PROJECT STATUS	Riba Stage 5
CLIENT	Manchester City Council
PROJECT	Our Town Hall
DRAWING TITLE	Chimney Number CS06 Proposed repairs
SIZE & SCALE	A1: 1:20
DRAWING STATUS	S4 - Construction

OTH-PUR-TH-RF-DWG-A-4166 02

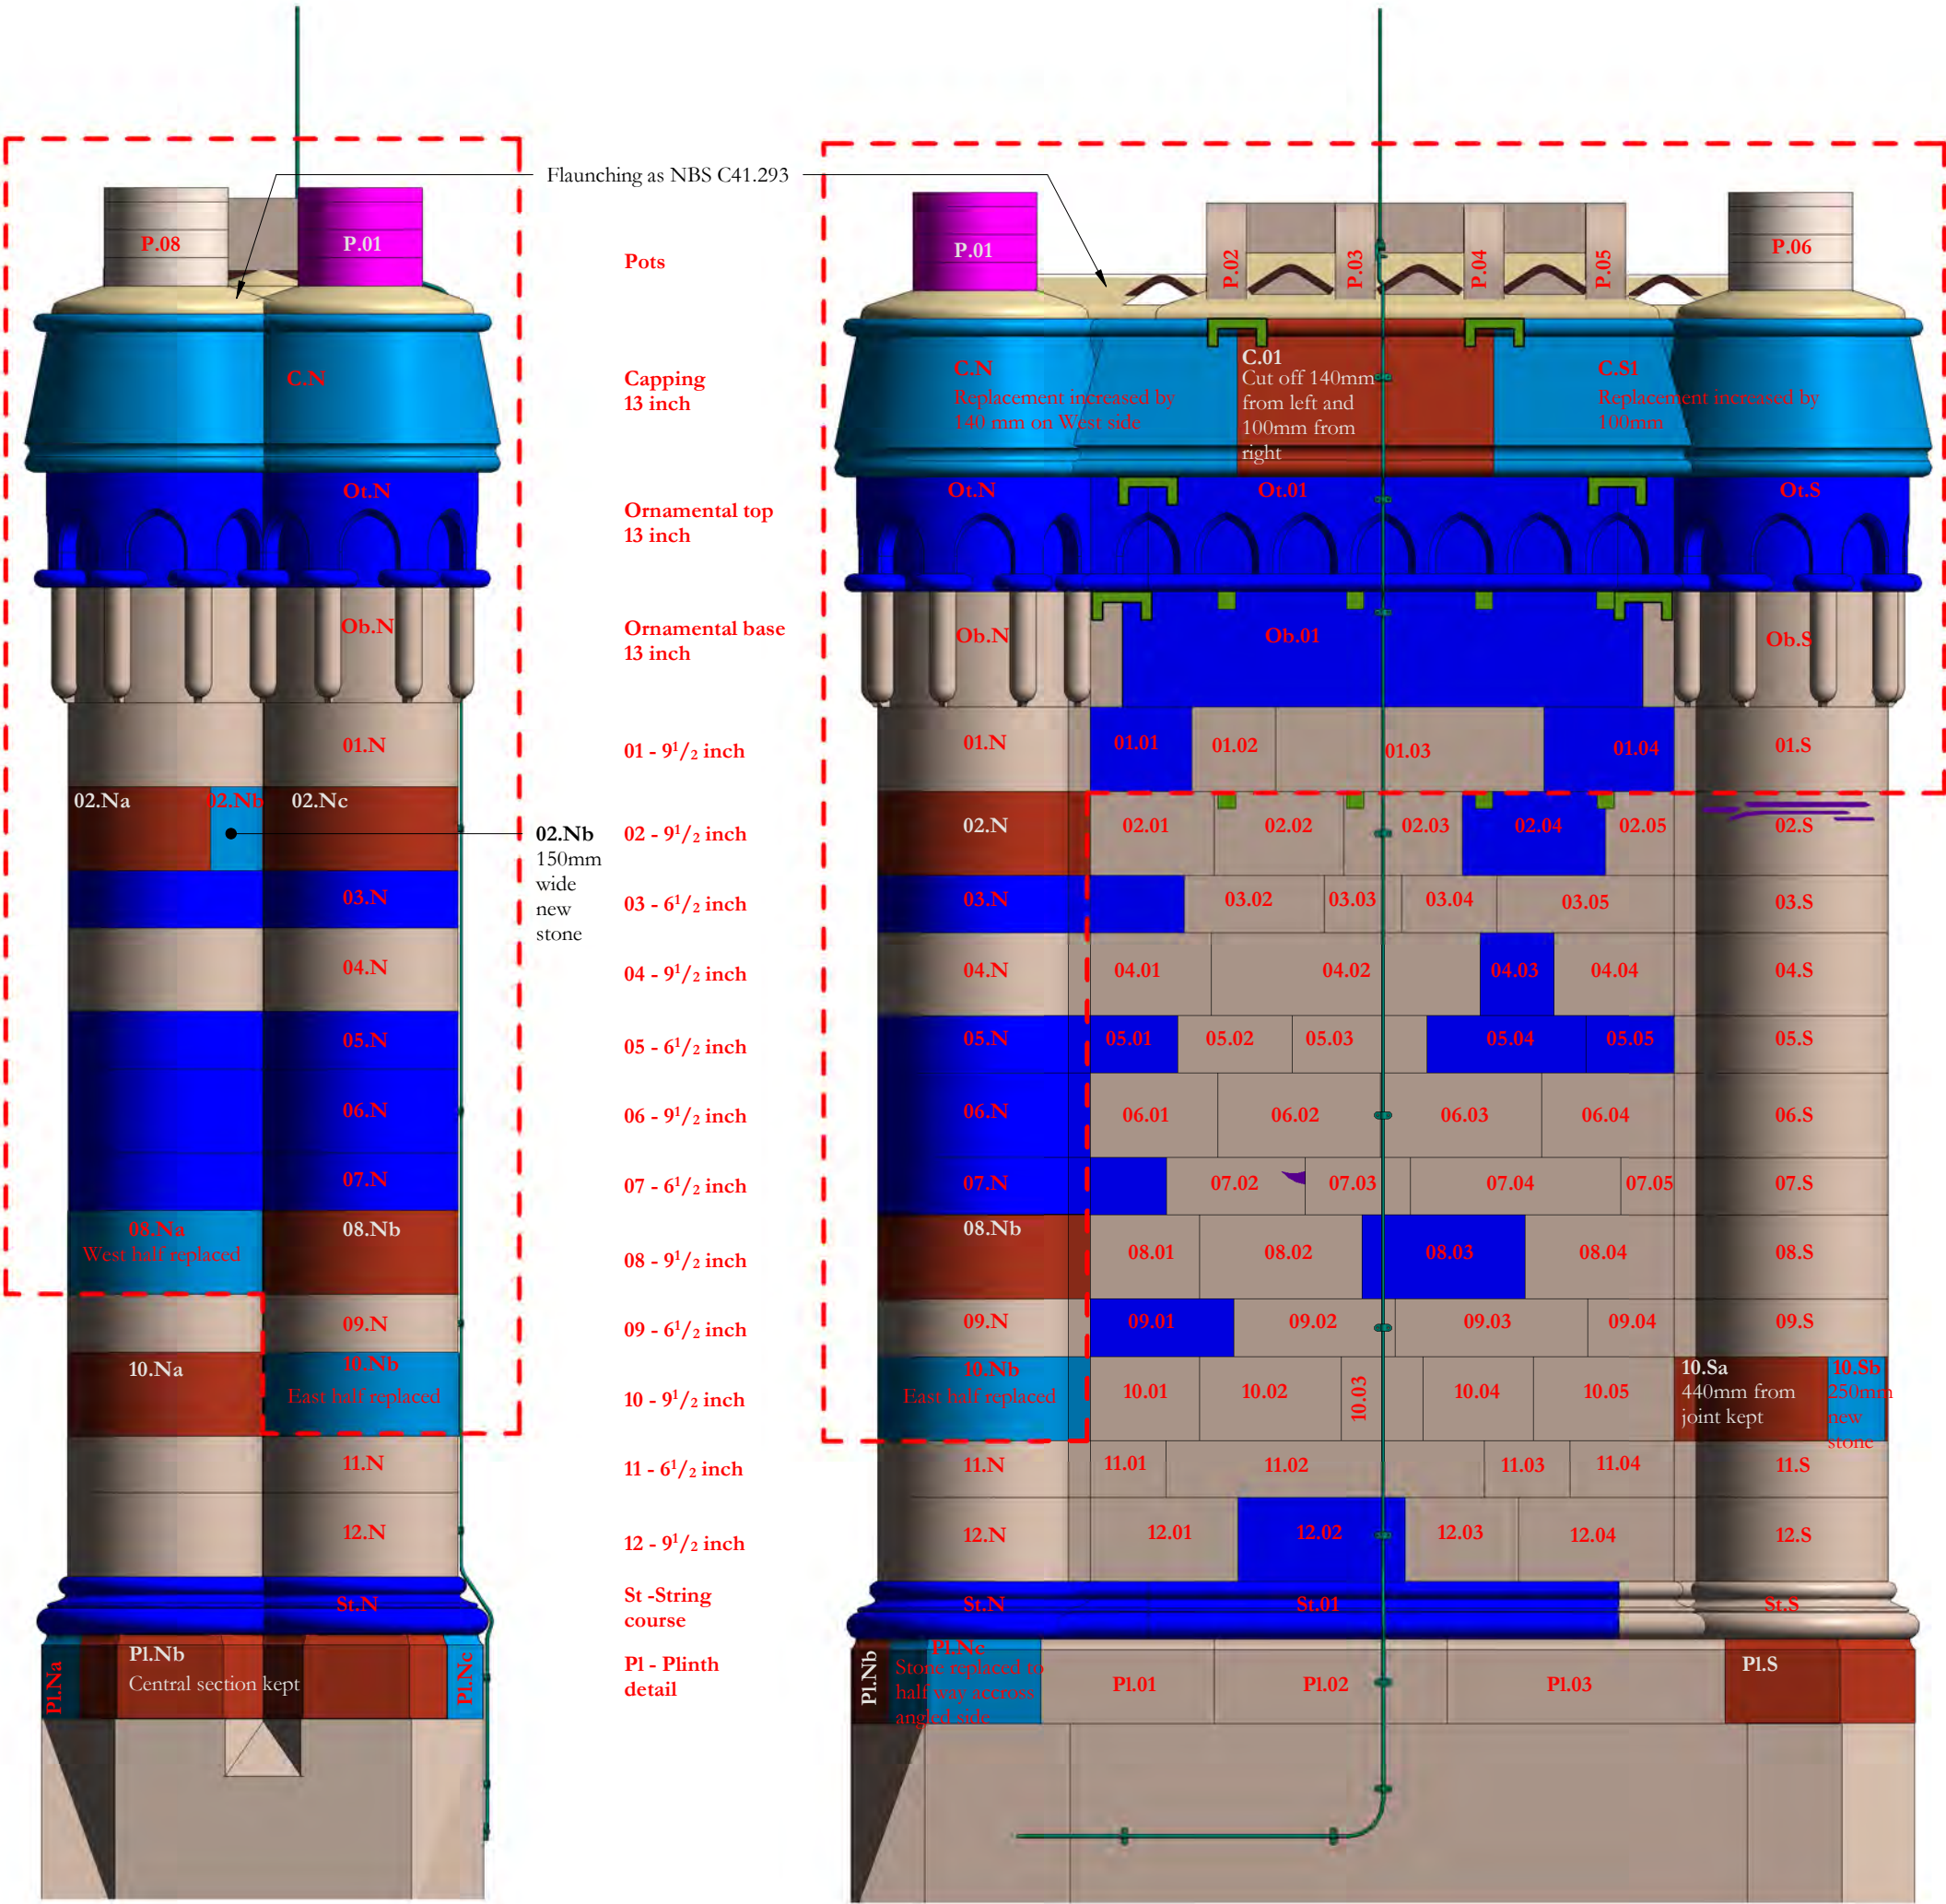
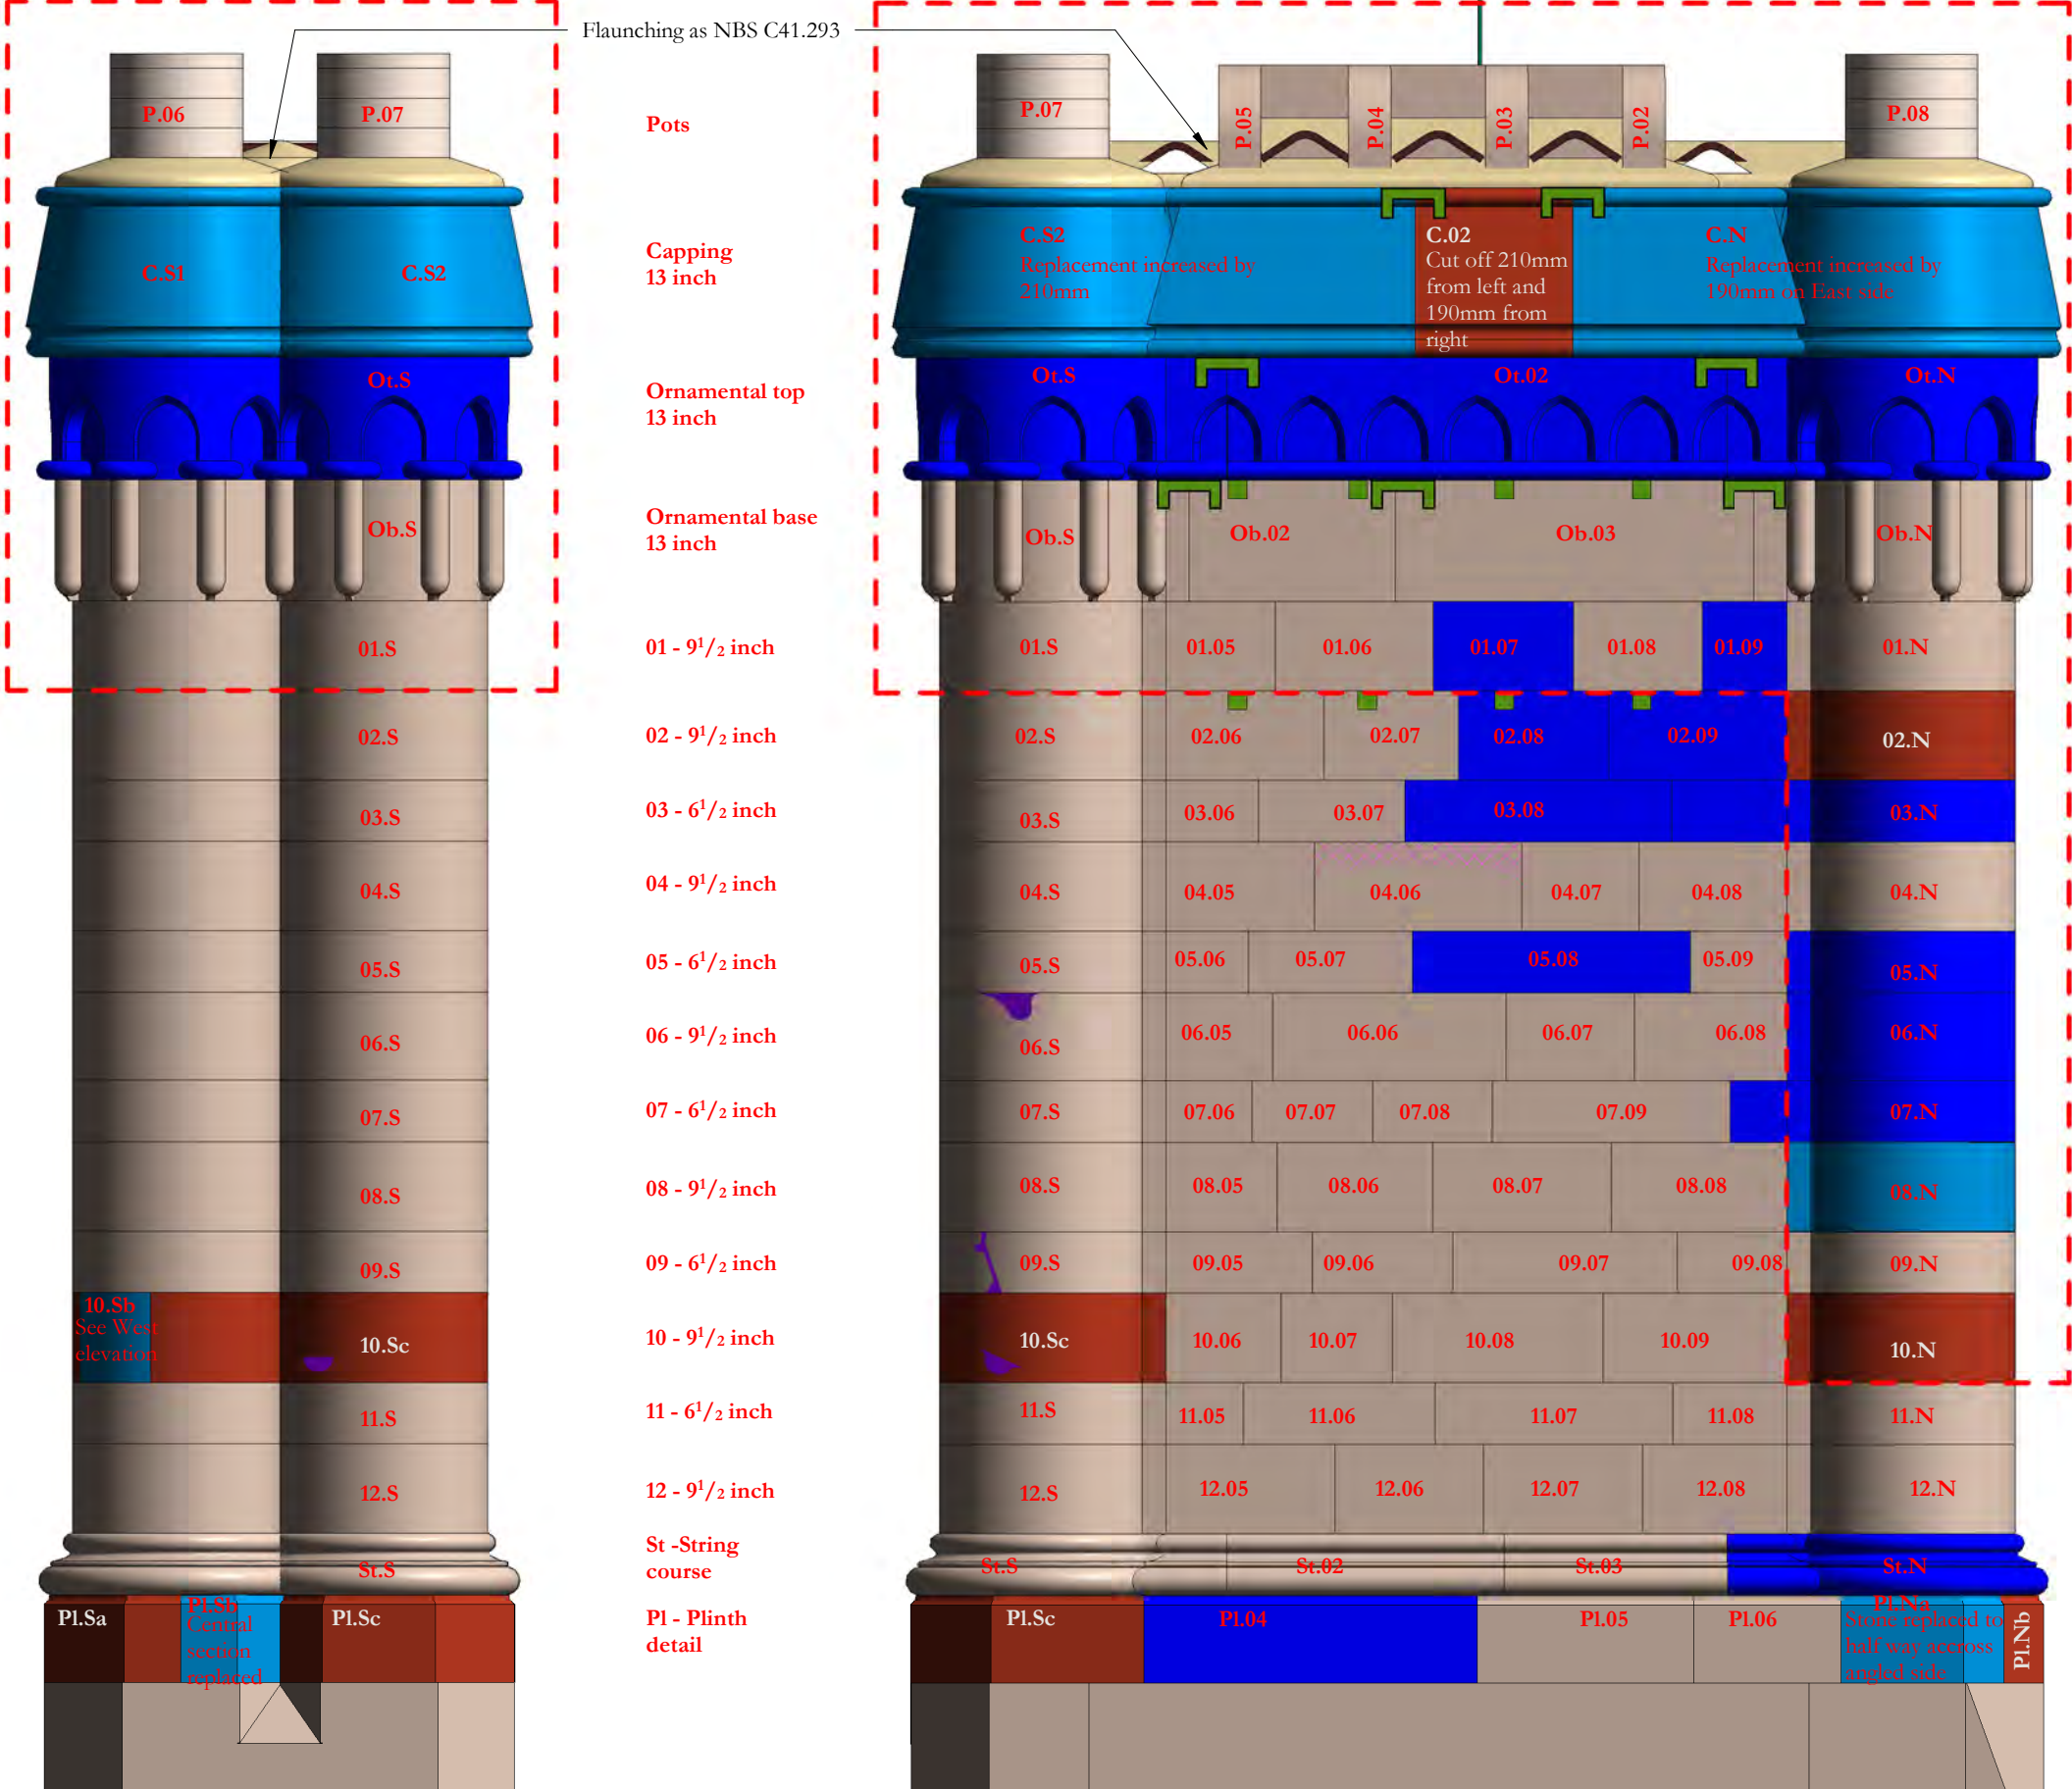
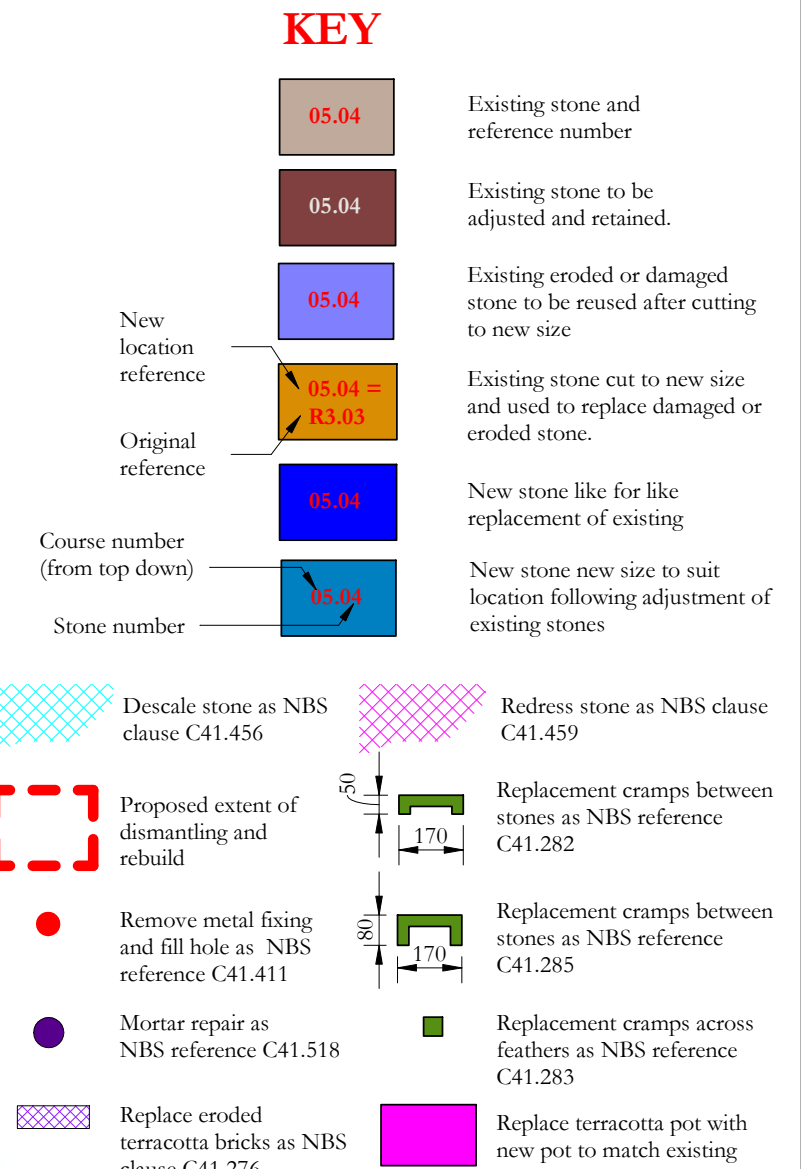
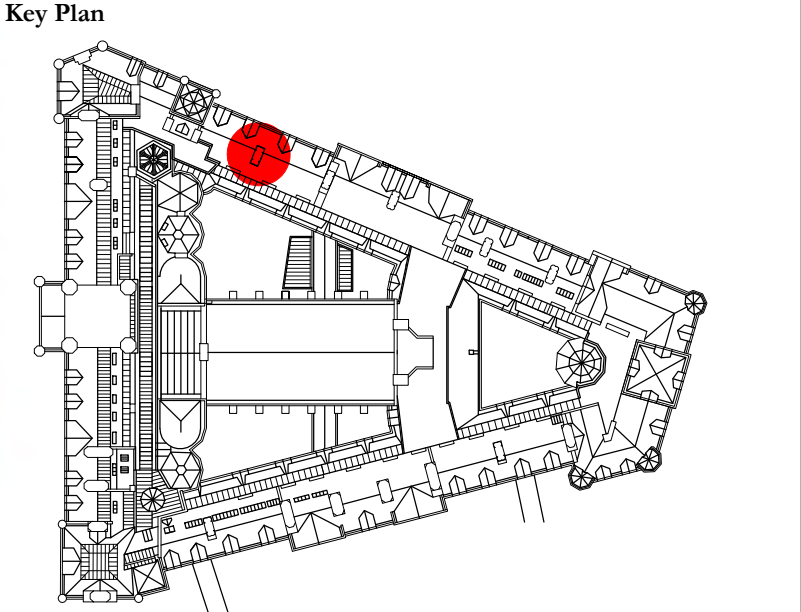
Revision 02: Circular flue component 07.N to be replaced and combined with 07.01 and 07.10 to form tie to main body of chimney. Components 03.N, 03.01 and 03.09 combined into one component to tie flue to main body of chimney. Bronze cramps added across feathers to section of chimney to be rebuilt. Lightning protection added.

Revision 01: Drawing updated post validation survey
